DATE MAILED: 03/24/2006

Application No.	Applicant(s)	
			BLACK, CHARLES D.	
Office Action Summary		10/602,199 Examiner	Art Unit	
	•			
	The MAILING DATE of this communication ann	SANG KIM	3654	
	The MAILING DATE of this communication appears on the cover sheet with the correspondence address Period for Reply			
WHIC - Exter after - If NO - Failu Any r	CRTENED STATUTORY PERIOD FOR REPLY CHEVER IS LONGER, FROM THE MAILING DATE is not soft time may be available under the provisions of 37 CFR 1.13 SIX (6) MONTHS from the mailing date of this communication. In period for reply is specified above, the maximum statutory period we to reply within the set or extended period for reply will, by statute, eply received by the Office later than three months after the mailing and patent term adjustment. See 37 CFR 1.704(b).	ATE OF THIS COMMUNICATION 16(a). In no event, however, may a reply be tim rill apply and will expire SIX (6) MONTHS from cause the application to become ABANDONE	N. nely filed the mailing date of this communication. D (35 U.S.C. § 133).

Application/Control Number: 10/602,199

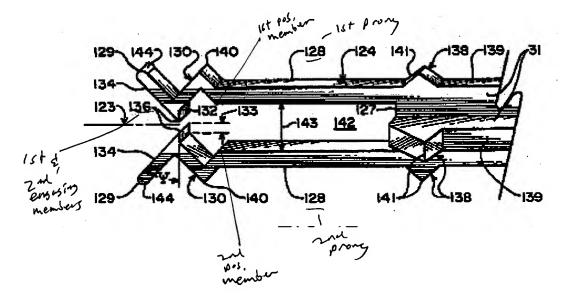
With respect to claim 1, Black '739 shows an end member (14) including a tongue member (106) extending from an end shoulder (62), wherein said tongue member has a plurality of teeth on opposing sides (104); and a handle structure (38) including a first prong (128) and a second prong (128); wherein said first prong includes a first engaging member (136) and a first positive member (shoulder to right of 136); wherein said second prong includes a second engaging member (136) includes a second positive member (shoulder to right of 136); wherein said engaging members and said positive members catchably engage said teeth, see figures 8-13 and illustrations below.

With respect to claim 5, Black '739 shows the positive members are nub structures, see figure 13.

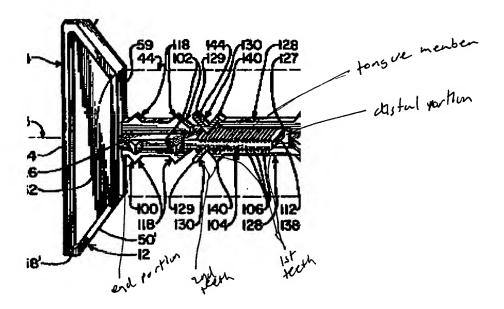
With respect to claims 6-8, Black '739 shows the plurality of teeth transverse with respect to a longitudinal axis (123) of the tongue member, which is a flat structure.

With respect to claims 9-10, Black '739 shows the plurality of teeth (104) are comprised of a plurality of first teeth (i.e., a first half of teeth) and a plurality of second

teeth (i.e., a second half of teeth), wherein said first teeth extend from a distal portion of said tongue member, wherein said second teeth extend from said tongue member between said first teeth and said end shoulder (62), and wherein said engaging members catchably engage said second teeth (i.e., a second half of teeth) and wherein said positive members catchably engage said first teeth.

With respect to claims 11 and 15-20, as stated above, Black '739 teaches applicant's claimed device in an alternative embodiment by reversing the structure to have the handle with the tongue member and the end member to include the prongs without changing the spirit or scope of the invention, see column 8, lines 65-67, through column 9, lines 1-5.
